Date: 15th May 2024
PINS ref APP/X5210/C/24/3338107
LPA ref: EN23/1002
Email: Joshua.Cheung@camden.gov.uk
Direct Line: 020 7974 3383

**Town and Country Planning Act 1990 as amended
Planning Appeal Statement (Local Planning Authority)**

Site: 49-51 Camden High Street, London, NW1 7JH, and Land and buildings in Carlow Street and Miller Street

Enforcement Notice dated 22nd December 2023

Figure 1 – Photos of the rear area of the site in September 2019. Blue arrow indicates the position of where the as-built unauthorised extension is. Orange arrow indicates the position of where the as-built unauthorised flue and equipment behind No 49. Awnings present.

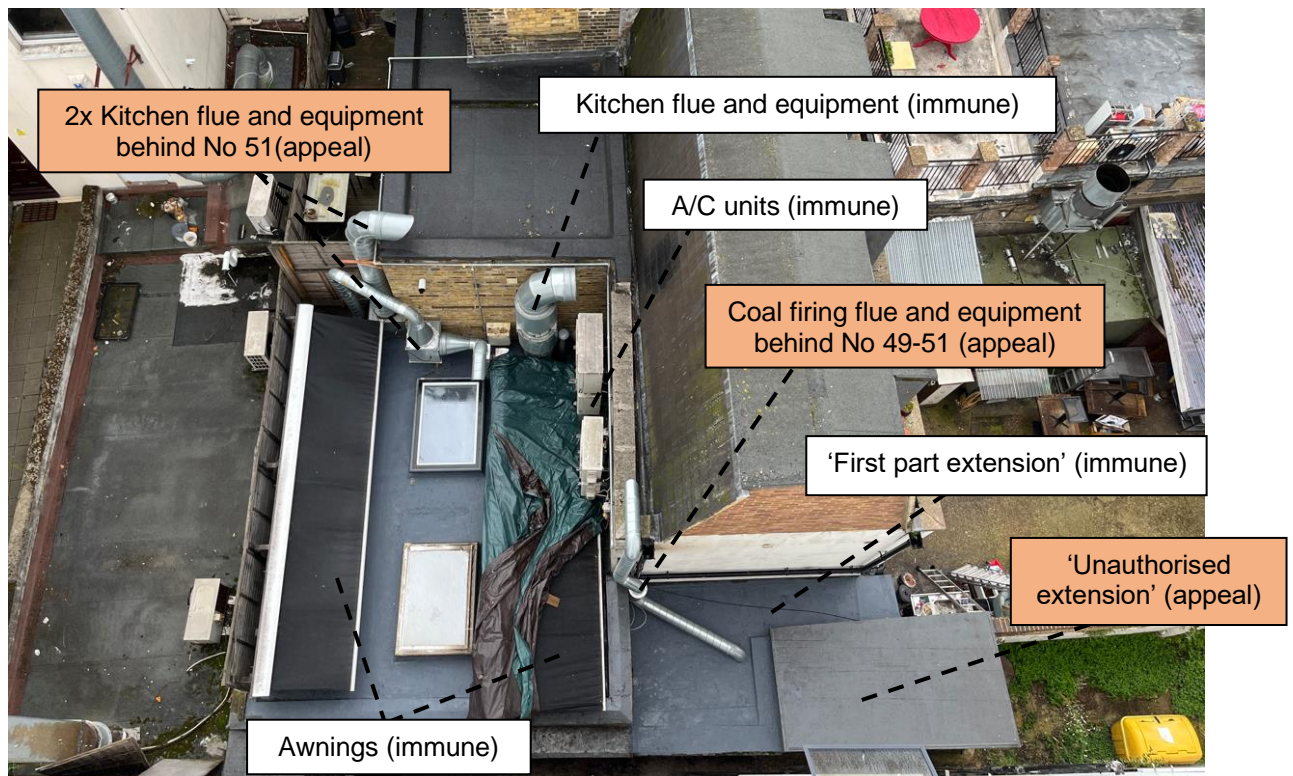
- 5.10 The Council has recently received more photos that further substantiate a ‘2019 round’ of refurbishments (see Figure 1). These photos were taken in September 2019 in connection with a Food Safety complaint made to the Council. It is clear that the unauthorised extension and the flue and ancillary plant equipment behind No 49-51 – subject of this appeal – was not in place at this time. The invoices are dated Between August - September 2019. The claim that all works were completed then invoiced after is false.

- 5.11 In fact, the ‘first part extension’ was not yet built either, where it appears there was a prior timber and polycarbonate lean-to infill. The immune awnings are also visible – pursuant to the photos provided by the appellant.

- 5.12 These new photos, alongside the evidence within the enforcement delegated report, on the balance of all probabilities all works alleged in the notice were installed during the ‘2021 round’ of refurbishments, thus were not immune from action prior to the service of the notice.

Figure 5 – Accumulation of oil-based byproduct from the kitchen extracts' discharge on adjacent roofs (red circles).

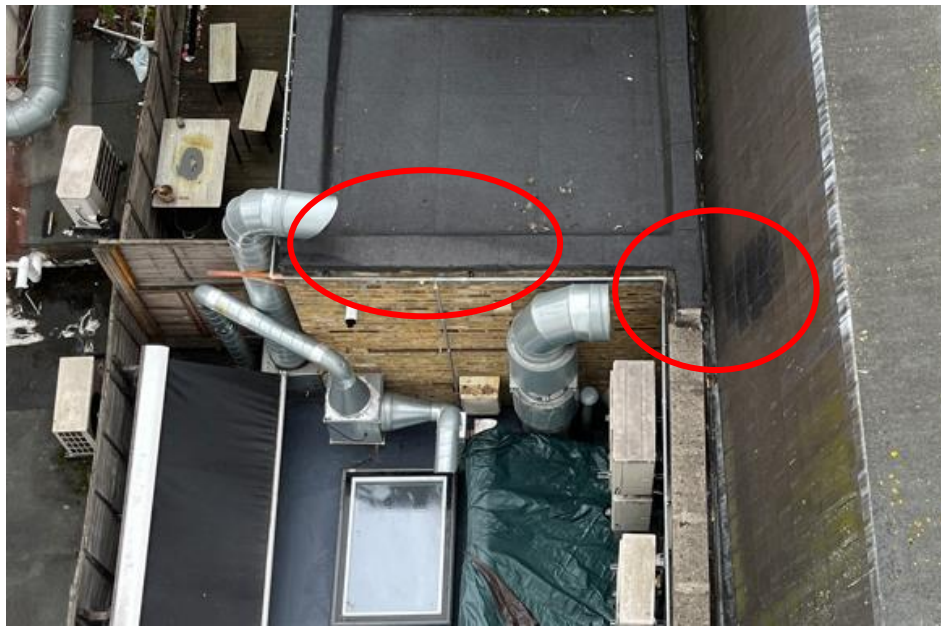
6.32 If the Inspector is minded to consider the unauthorised flues and equipment as good quality, Figure 5 shows an accumulation of an oil-based byproduct on the adjacent roofs from cooking fumes, which would be indicative that the flues and equipment are not/poorly maintained, reflecting the lack of a management plan (for both the existing immune flue and unauthorised). Neighbours would remain consistently impacted by the unauthorised works.

Figure 6 – Position of No 51 in relation to Carlow House.

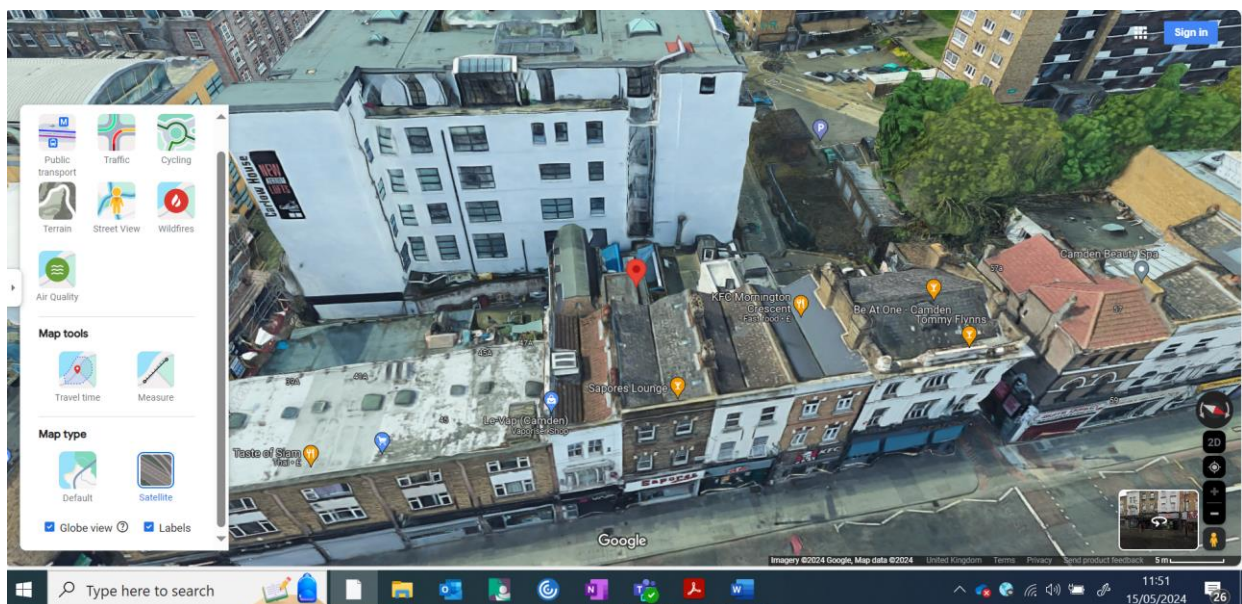
6.33 Lastly, it should be noted that the Council believes that any amended proposal to increase the height of each of the three flues' would not be an appropriate solution moving forward. As this would exacerbate the outlined design harm the Council has set, notably through the introduction of even more dominant steel ducting. Further, particular regard should be paid to the rear of No 51 being directly in front of the residential windows of Carlow House (Figure 6).
